FINAL EVALUATION REPORT
REVIEW OF RESPONSIBLE PARTIES'
REVISED RI/FS WORK PLAN
OLD CITY OF YORK LANDFILL SITE
SEVEN VALLEYS, PENNSYLVANIA

Subject: REM III Program - EPA Contract No. 68-01-7250
Work Assignment No. 29-34B4
Old City of York Landfill Site
Seven Valleys, Pennsylvania
FINAL REPORT - EVALUATION OF RESPONSIBLE PARTIES'
REVISED RI/FS WORK PLAN

FINAL EVALUATION REPORT
REVIEW OF REVISED RI/FS WORK PLAN

OLD CITY OF YORK LANDFILL SITE
SEVEN VALLEYS, PENNSYLVANIA

FIGURE 1

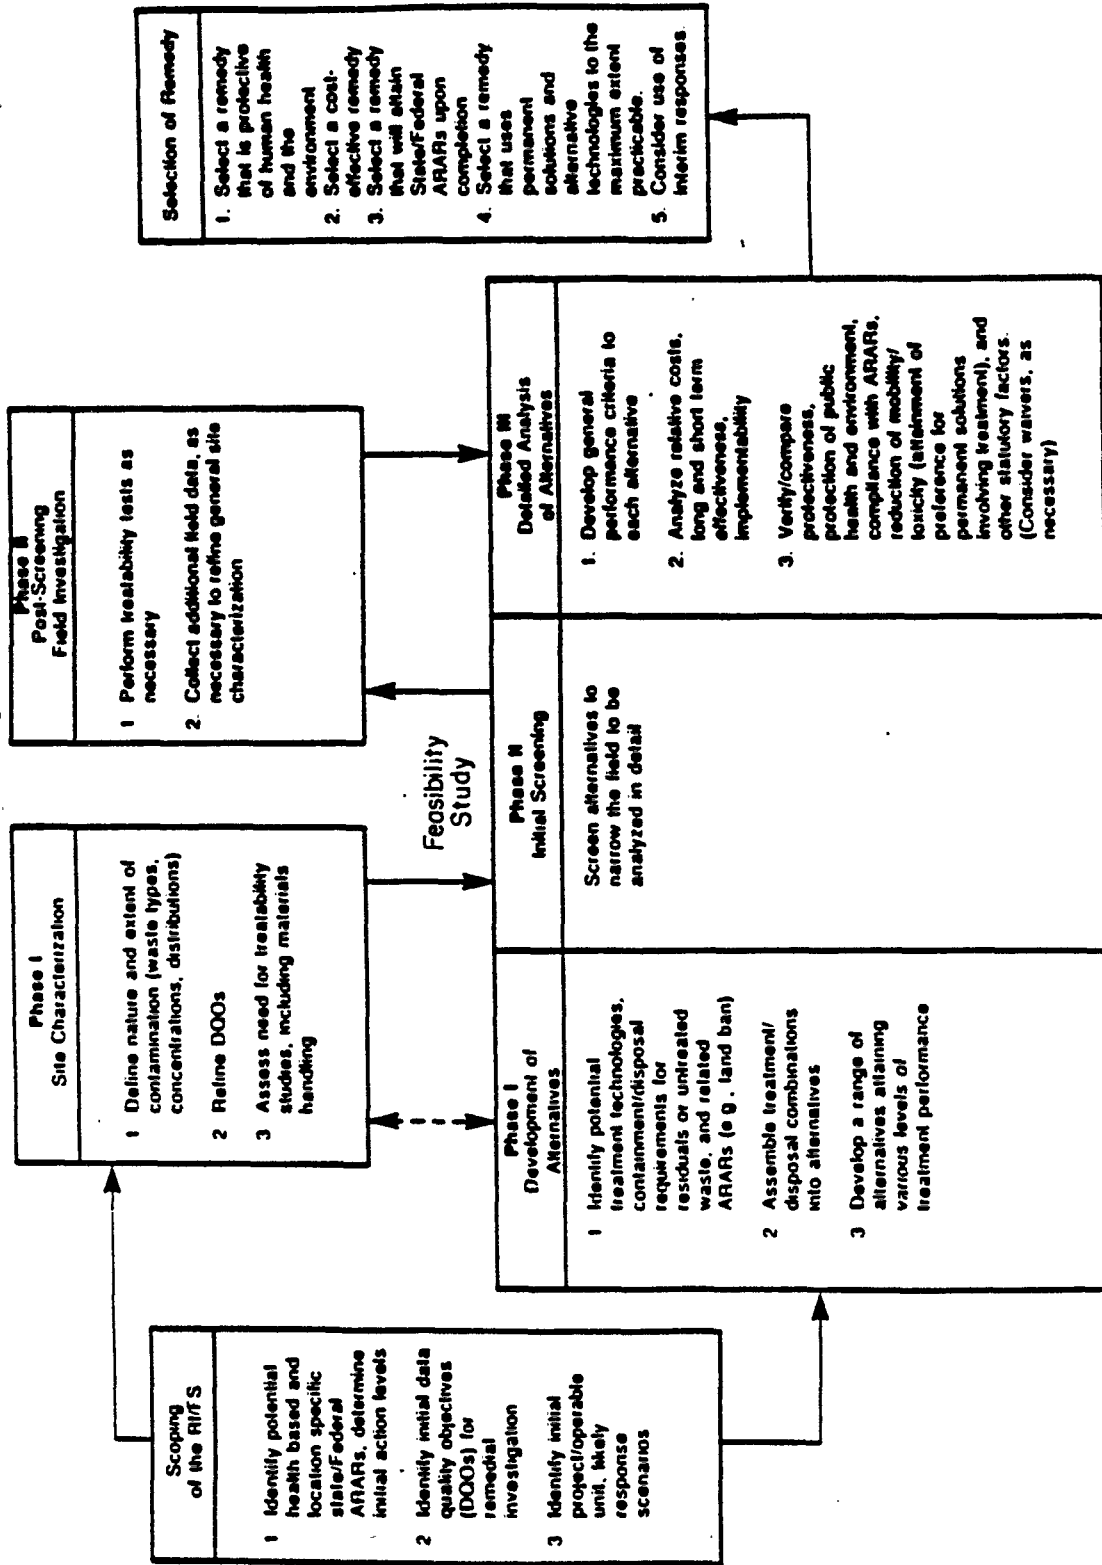
As previously mentioned in Section 3.0, the RI/FS scoping process did not appear to be well understood by the work plan authors. This is evidenced by the discussion of the preliminary risk assessment, ARAR determination, and preliminary identification of remedial technologies. The revised work plan indicates that these activities will be conducted during the "Site Characterization" Phase of the RI. As shown on the attached figure, these activities should have been performed during the scoping of the RI/FS. This would provide the framework for developing the RI/FS Work Plan. As a result, the Revised Work Plan may be deficient with respect to collecting the appropriate quantity and quality of data. It is recommended that cleanup action levels be established for groundwater, surface water, and soils. The analytical detection limits

should be as close as possible to the action levels in order to assess health risks and evaluate remedial technologies.
